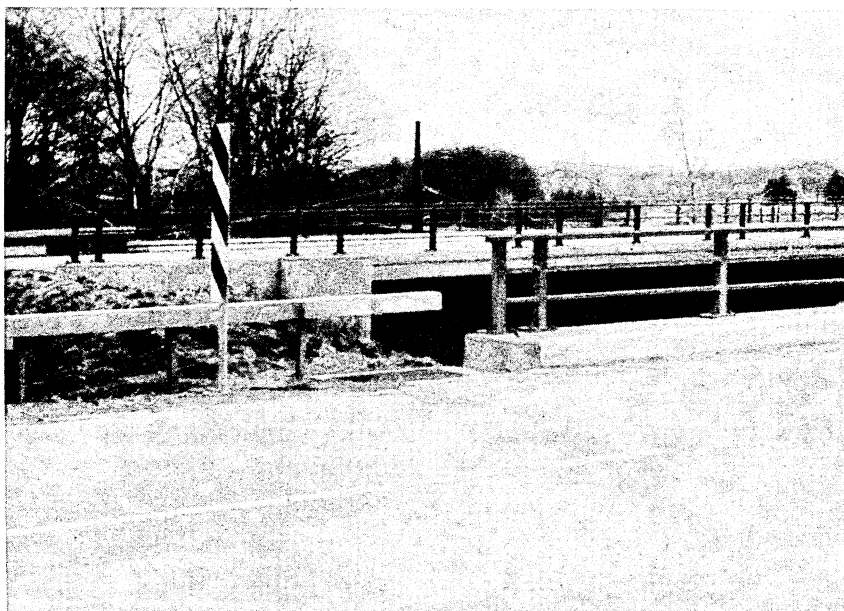
Mr. W. MAY. I believe that again shows the problem of communication and education down to the people who make the installations of these new systems. Is that not true?

Mr. W. MAY. Somebody installed this improperly.

Mr. W. MAY. I notice in the photograph here there is a section of guiderail, running at a 90° angle to the shoulder guiderail. Is that designed to prevent people from going down into the space between the twin structures?

I was just wondering if that would function properly. Can you see the left end of the photograph?

Mr. GRAHAM. Yes. We have never tested it at 90°. I am not sure that anything would prevent a vehicle going fast enough from getting down in there. This, I would think, would be a credible job though.
